**FPL Energy**  
**Seabrook Station**

June 8, 2006  
SBK-L-06131  
Docket No. 50-443

Seabrook Station  
Response to Request for Additional Information Regarding  
Emergency License Amendment Request 06-07  
“Containment Enclosure Emergency Air  
Cleanup System Allowed Outage Time One Time Change”

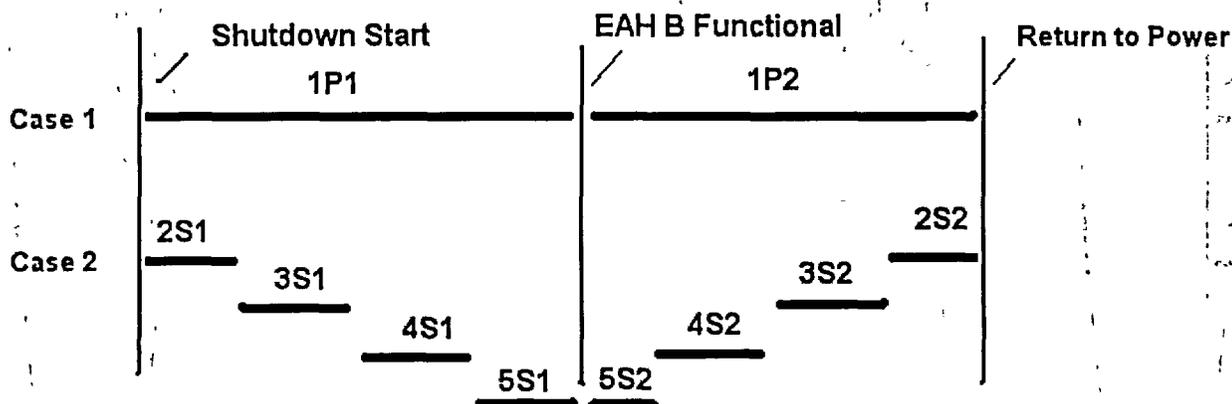
Section 5.0 page 10 provides the quantitative results of the internal events ICCDP analysis, and compares the calculated risk of completing repairs while operating over a 14-day period ( $1.31E-6$  ICCDP), compared to the risk of shutting down to conduct repairs ( $1.5E-6$  ICCDP). The staff is unable to confirm the validity of the analyses. Specifically, the licensee identified that the 14-day ICCDP for on-line repair is  $1.31E-6$ , which represents the delta risk above the nominal full power risk over 14 days. The staff infers that the seven day ICCDP would be 50% of this value, or approximately  $6.5E-7$ . The licensee states (page 10) that if it were to shut down the plant to repair the inoperable EAHF, an additional ICCDP risk of  $2.0E-7$  to  $3.0E-7$  would be incurred for shutting down and returning to power. The staff calculates that the total risk of operating for 7 days, then shutting down to repair the EAHF and return the unit to service, would involve  $8.5E-7$  to  $9.5E-7$  ICCDP, which is inconsistent with the licensee's estimate of  $1.5E-6$ . The licensee is requested to provide a more detailed basis for its ICCDP value of  $1.5E-6$  for shutting down to make repairs.

The integrated, full scope, all modes PRA model was used to calculate the incremental risk assuming the plant stays at power for the 7 day AOT, then shuts down to Mode 5 to repair EAH-FN-31B. The current schedule as of 6/7/06 1100 was used to develop the duration in the various shutdown modes. Note that EAH is required to provide equipment cooling to the RHR pumps in the shutdown cooling mode such that the calculation reflects the impact of EAH-FN-31B out of service throughout Mode 5, in accordance with the schedule.

Two cases were identified. Case 1 is the case for staying at power to repair EAH fan 31B. Case 2 is the case that quantifies the incremental core damage probability for shutting down to repair EAH fan 31B. The starting point (Shutdown Start) for the analysis uses the end of the current action statement. The return to full power was used as the end point for the analysis. Both cases use the same total time. A graphic of the individual configurations quantified is shown below

**Conclusion:** The best option, from an overall risk perspective, is to remain at power and repair the EAH fan. Using the same overall duration, the ICCDP for the shutdown case is a factor of 2.4 higher than the case for staying at power to repair the fan. Both cases use the same start and endpoints, so that the numeric results can be directly compared.
